U.S. DEPARTMENT OF
ENERGY

Subject: Transmittal of the Part B Permit Application for Renewal of the Los Alamos National Laboratory Hazardous Waste Facility Permit, EPA ID #NM0890010515

Figure 17 TA-54, Area G, Pad 9 (Transuranic Waste Inspectable Storage Project (TWISP) Domes 229, 230, 231 & 232)

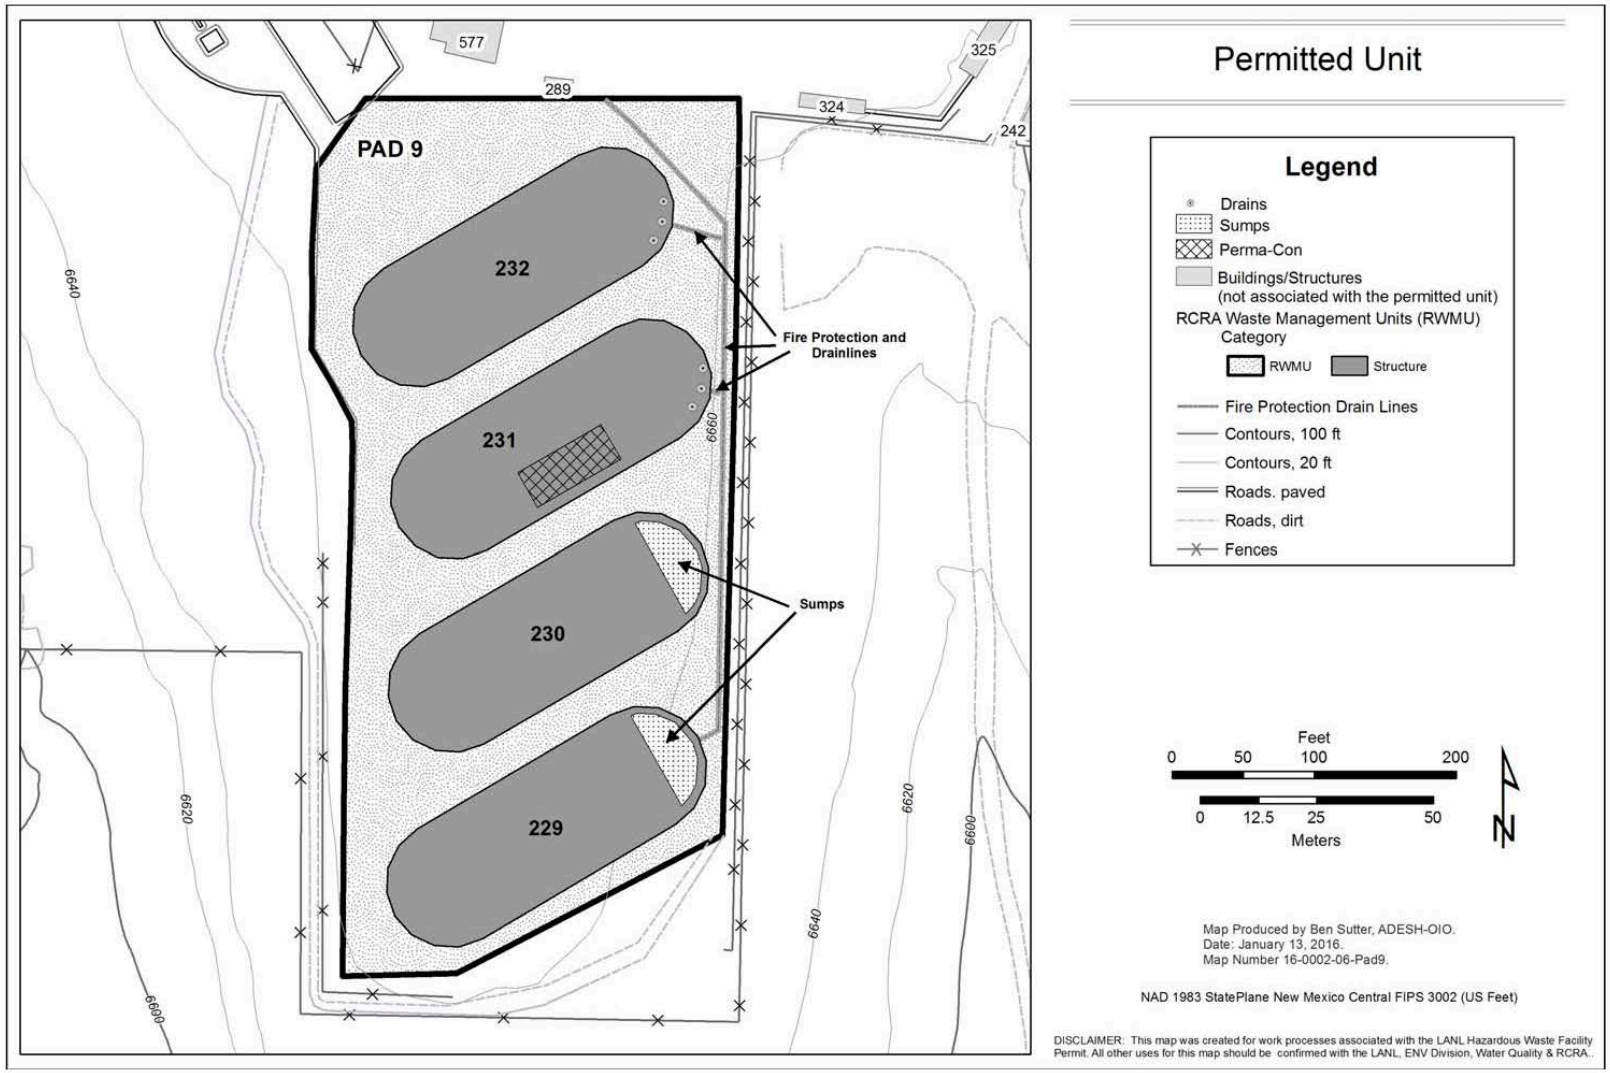
Figure 17 TA-54, Area G, Pad 9 (Transuranic Waste Inspectable Storage Project (TWISP) Domes 229, 230, 231 & 232)	Figure 28	Propose to renumber Figure 28 in the current 2010 Permit to new Figure 17 (Technical Area (TA)-54, Area G, Pad 9 (TWISP Domes 229, 230, 231 & 232)). No changes were made to the figure, however, the title of the figure was updated for consistency.	The Permittees propose to rearrange and renumber figures to align with proposed changes and reduce redundancy within the attachment.
Figure 18 TA-54, Area G, Pad 1	Figure 29	Propose to renumber Figure 29 in the current 2010 Permit to new Figure 18 (TA-54, Area G, Pad 1) and propose to update the figure title.	The Permittees propose to rearrange and renumber figures to align with proposed changes and reduce redundancy within the attachment.

Figure 19 TA-54, Area G, Pad 3

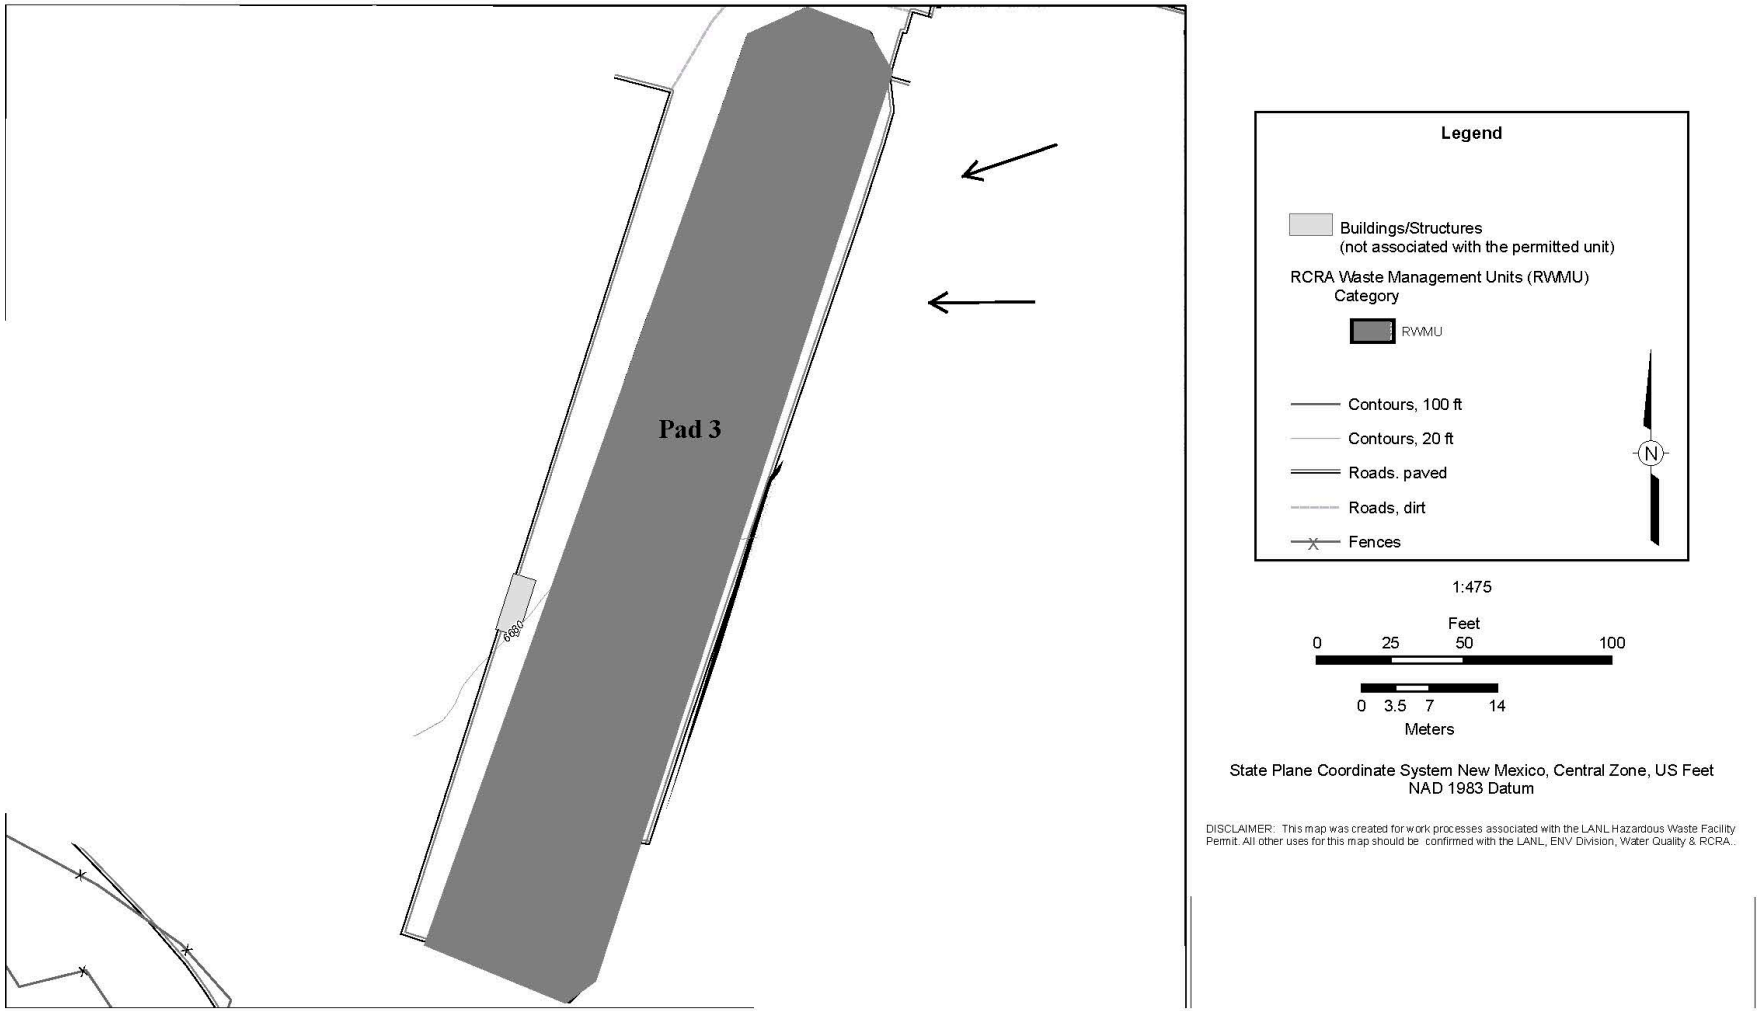
New Figure Number	2010 Permit Figure Number(s)	Proposed Modification	Justification
Figure 19 TA-54, Area G, Pad 3	Figure 30	Propose to renumber Figure 30 in the current 2010 Permit to new Figure 19 (Technical Area (TA)-54, Area G, Pad 3) and propose to update the figure title.	The Permittees propose to rearrange and renumber figures to align with proposed changes and reduce redundancy within the attachment.
Figure 20 TA-54, Area G, Pad 10	Figure 31	Propose to renumber Figure 31 in the current 2010 Permit to new Figure 20 (TA-54, Area G, Pad 10) and propose to update the figure title.	The Permittees propose to rearrange and renumber figures to align with proposed changes and reduce redundancy within the attachment.
Figure 21 TA-54, Area G, Pad 5 (Domes 49 and 224; and Storage Sheds 114, 145, 146, 177, 1027, 1028, 1030, and 1041)	Figure 32	Propose to renumber Figure 32 in the current 2010 Permit to new Figure 21 (Technical Area (TA)-54, Area G, Pad 5 (Domes 49 and 224; and Storage Sheds 114, 145, 146, 177, 1027, 1028, 1030, and 1041)) and propose to update the figure title.	The Permittees propose to rearrange and renumber figures to align with proposed changes and reduce redundancy within the attachment.

Figure 22 TA-54, Area G, Pad 6, Domes 153 & 283

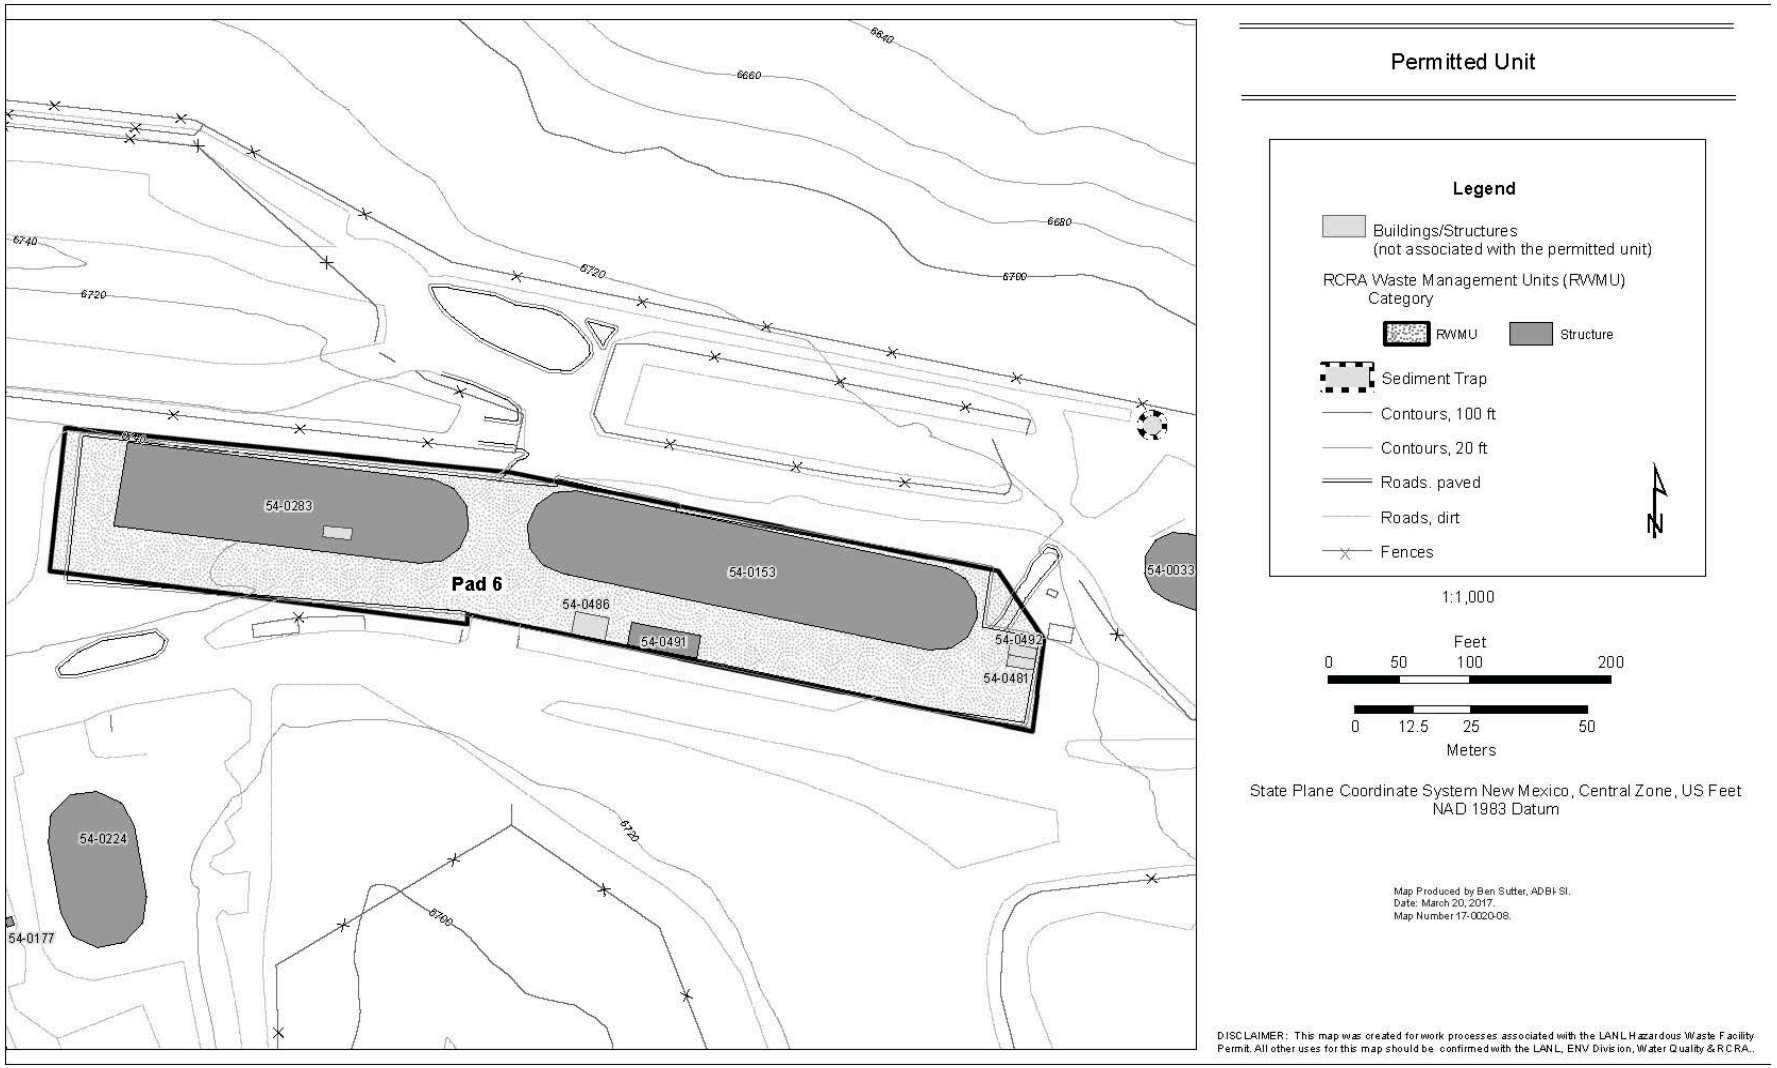
Figure 22 TA-54, Area G, Pad 6, Domes 153 & 283	Figure 33	Propose to renumber Figure 33 in the current 2010 Permit to new Figure 22 (TA-54, Area G, Pad 6, Domes 153 & 283) and propose to update the figure title.	The Permittees propose to rearrange and renumber figures to align with proposed changes and reduce redundancy within the attachment.
Figure 23 TA-54, Area G, Storage Shed 8	Figure 34	Propose to renumber Figure 34 in the current 2010 Permit to new Figure 23 (TA-54, Area G, Storage Shed 8) and propose to update the figure title.	The Permittees propose to rearrange and renumber figures to align with proposed changes and reduce redundancy within the attachment.
Figure 24 TA-54, Area G, Building 33	Figure 35	Propose to renumber Figure 35 in the current 2010 Permit to new Figure 24 (TA-54, Area G, Building 33) and propose to update the figure title.	The Permittees propose to rearrange and renumber figures to align with proposed changes and reduce redundancy within the attachment.

Figure 25 TA-54, Area G, Pad 11

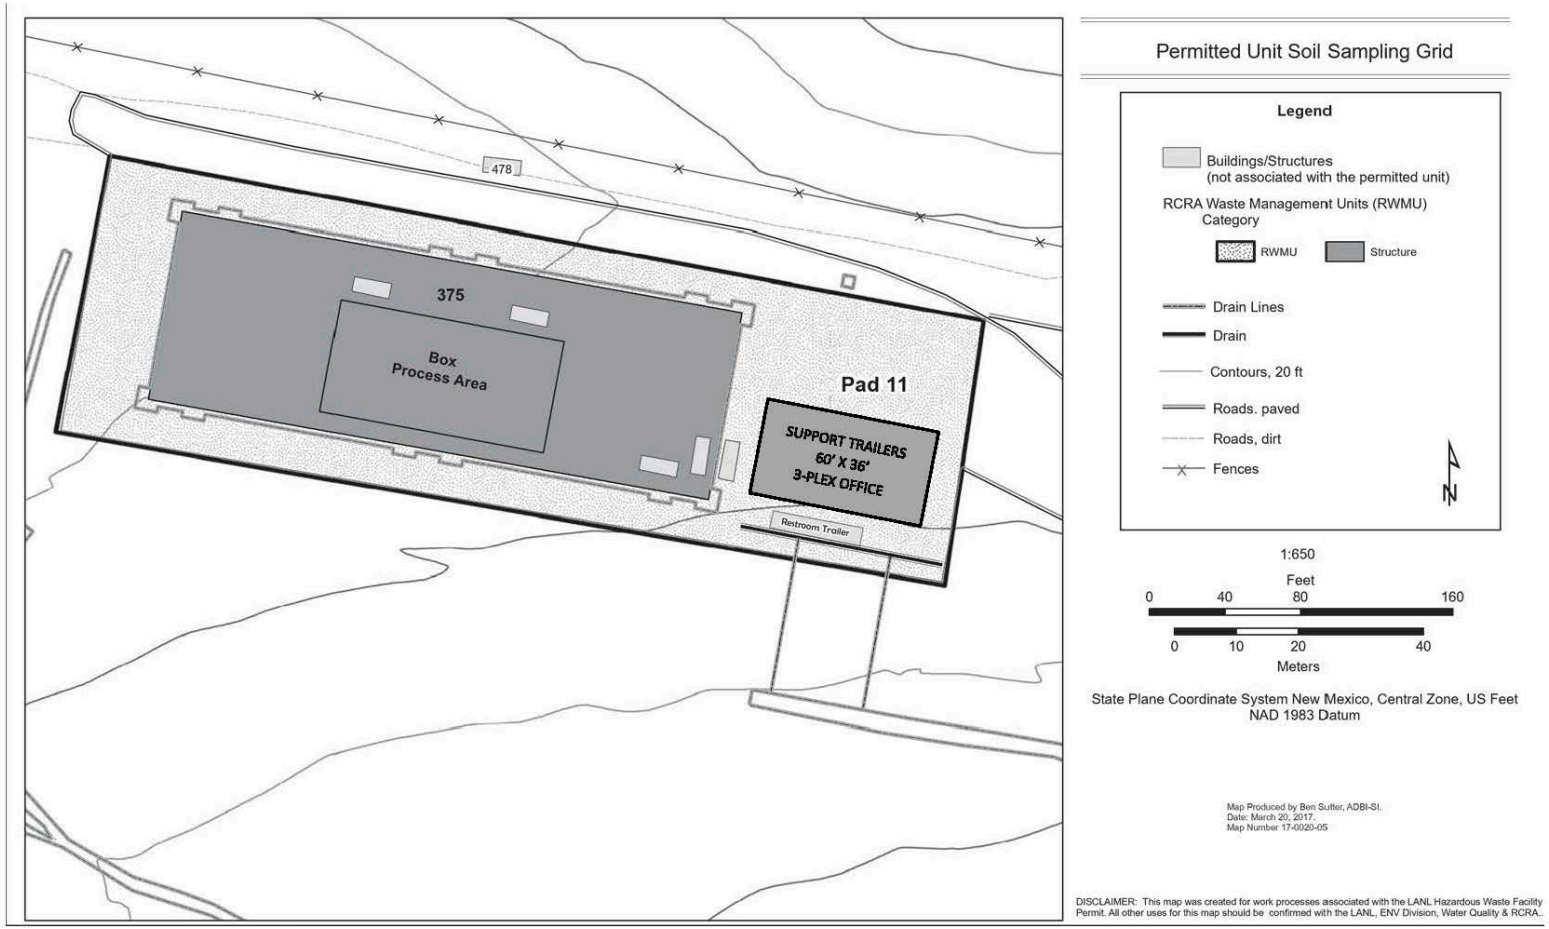
Figure 25 TA-54, Area G, Pad 11	Figure 36	Propose to renumber Figure 36 in the current 2010 Permit to new Figure 25 (TA-54, Area G, Pad 11) and propose to update the figure title.	The Permittees propose to rearrange and renumber figures to align with proposed changes and reduce redundancy within the attachment.

Figure 29 TA-55, Building 4, Room 401, Storage Tank System Process Flow Diagram

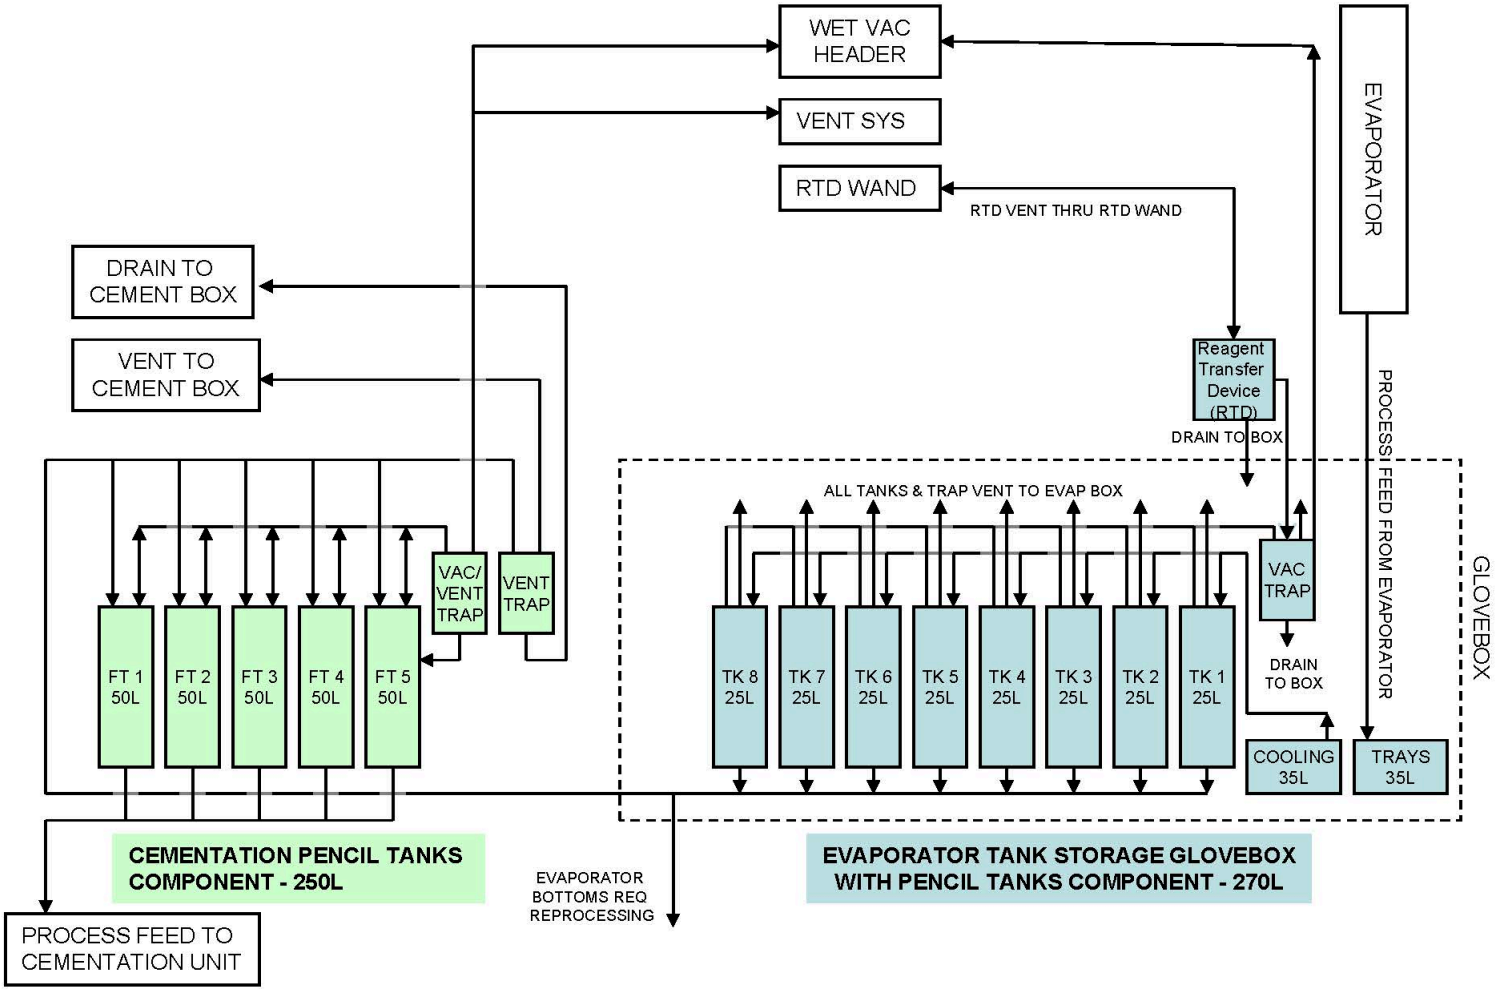
Figure 29 TA-55, Building 4, Room 401, Storage Tank System Process Flow Diagram	Figure 47	Propose to renumber Figure 47 in the current 2010 Permit to new Figure 29 (TA-55, Building 4, Room 401, Storage Tank System Process Flow Diagram).	The Permittees propose to rearrange and renumber figures to align with proposed changes and reduce redundancy within the attachment.
Figure 30 TA-55, Building 4, Room 401, Cementation Unit Process Flow Diagram	Figure 48	Propose to renumber Figure 48 in the current 2010 Permit to new Figure 30 (TA-55, Building 4, Room 401, Cementation Unit Process Flow Diagram) and update the title of the figure.	The Permittees propose to rearrange and renumber figures to align with proposed changes and reduce redundancy within the attachment.
Figure 31 TA-54, Material Disposal Area (MDA) H	Figure 50	Propose to renumber Figure 50 in the current 2010 Permit to new Figure 31 (TA-54, Material Disposal Area (MDA) H) and update the title of the figure.	The Permittees propose to rearrange and renumber figures to align with proposed changes and reduce redundancy within the attachment.
